CITY PLANNING COMMISSION
1231 "I" STREET, SUITE 200, SACRAMENTO, CA 95814

- A. Negative Declaration
- B. Tentative Map to divide 1.0± developed acres into four single family lots in the Standard Single Family (R-1) zone.
- C. Subdivision Modification to establish lots without public street frontage.
- D. Variance to establish landlocked parcels.
- E. Variance to reduce the minimum required 15 foot rearyard setback to 13 feet for an existing dwelling.

LOCATION: 1024 Vinci Avenue

P90-164

Exhibit A (revised site Plan)

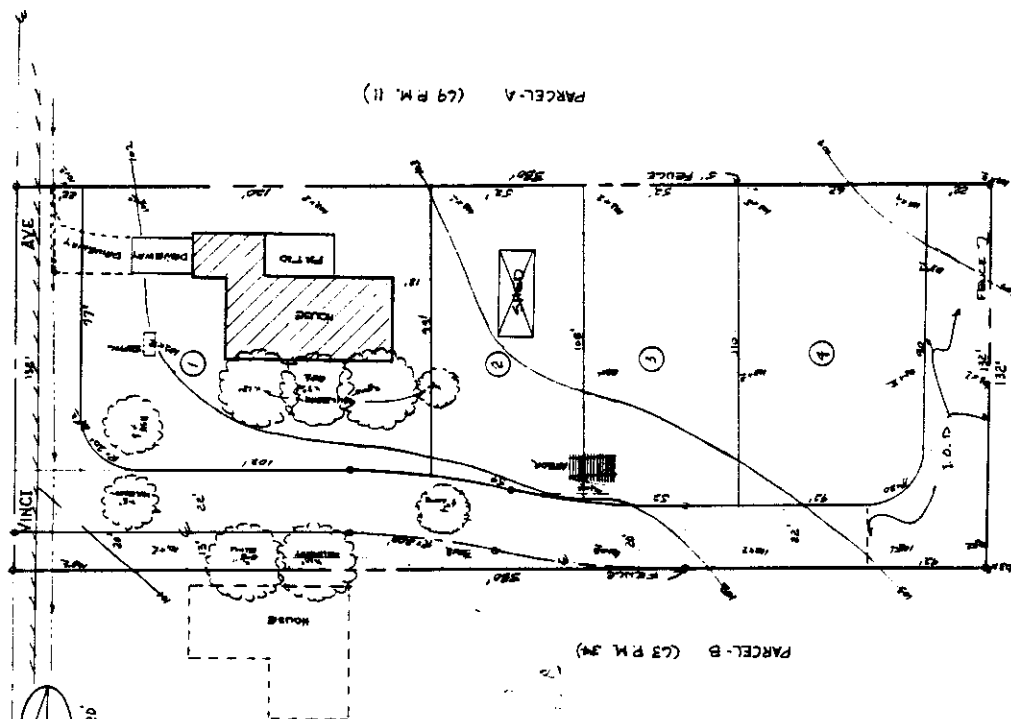
The applicant is requesting a tentative map to subdivide a single parcel into four single family lots (Exhibit A). The proposed subdivision will establish three landlocked parcels with no public street frontage. Access to these lots would be via a private driveway. A Subdivision Modification and Variance is required to establish landlocked parcels.

The applicant's original proposal attached as Exhibit B included a tentative map with four single family lots and a 20 foot wide driveway providing access to the lots. The applicant submitted a revised tentative map (Exhibit A) which proposes to subdivide the lot into four single family lots with a 22 foot wide north/south access road onto the subject site and a 22 foot wide Irrevocable Offer of Dedication (I.O.D.) along the southern boundary of the site. The applicant revised the tentative map based on various discussions with Planning staff and the City's Transportation Division.

As previously mentioned, the applicant is proposing to subdivide the parcel into four single family lots and provide a 22 foot wide access road (north/south) and a 22 foot wide I.O.D. along the southerly property line. The proposed lots will satisfy the minimum width (52 feet) and depth (100 feet) required for single family lots. The proposed tentative map indicates that the existing shed will be removed and the arbor will be relocated onto the existing developed lot.

Planning staff and the City's Transportation Division staff met with the applicant to discuss the proposed tentative map circulation pattern. The applicant was informed that the City's Transportation Division will be preparing a circulation study for the area. As a result of the study it is anticipated that a 80 foot east/west collector street will be needed between Vinci Avenue and Rood Avenue from Raley Boulevard to Sully Street (Exhibit C). It was, therefore, recommended to the applicant that a 40 foot wide I.O.D. be provided along the southern boundary of the proposed subdivision for the future 80 foot wide collector street. The applicant was unwilling to provide a 40 foot wide I.O.D. The applicant's proposed 20 foot wide I.O.D. is unacceptable to both the City's Transportation Division and Planning staff. Staff is, therefore, recommending denial of the applicant's proposal.

The standard public street width in the City is 44 feet. The applicant is proposing a minimum 20 foot wide public street for access (north/south) to the single family lots. A subdivision modification is required to reduce public street frontage to 20 feet in width. The applicant's 20 foot wide north/south street is unacceptable to both Planning staff and the City's Transportation Division and is inconsistent with the adopted street standards. The applicant was unwilling to meet the City's minimum public street (44 feet wide) standards and provide a 40 foot wide I.O.D. The City requirements could be met if the applicant eliminated one of the proposed lots. The applicant was not willing to eliminate one of the lots, therefore, the revised site plan reflecting a 22 foot wide public street could not be supported by the Subdivision Review Committee nor Planning staff.

A Variance is required to establish lots with less than 20 feet of public street frontage. The City's Subdivision Ordinance requires that all public streets comply with the City's adopted street standards. Any future subdividing of other lots in the area would be required to provide a 40 foot wide I.O.D if affected by the future circulation pattern and would be required to meet the City's standard public street width of 44 feet. Staff is, therefore opposed to the applicant's proposed tentative map.

The applicant is requesting a Variance to reduce the minimum required 15 foot rearyard setback to 13 feet. The proposed subdivision would create a 13 foot wide rearyard setback for an existing residential dwelling. The tentative map proposed could be redesigned with one less lot, in order for the existing dwelling to comply with the City's minimum required 15 foot rearyard setback. Staff, therefore, is opposed to the variance request.

- A. Ratify the Negative Declaration.
- B. Recommend denial of the tentative map and forward to City Council.
- C. Recommend denial of the subdivision modification and forward to City Council.
- D. Deny the variance to establish landlocked parcels subject to findings of fact which follow.
- E. Deny the variance to reduce the minimum required 15 foot rearyard setback to 13 feet subject to findings of fact which follow.
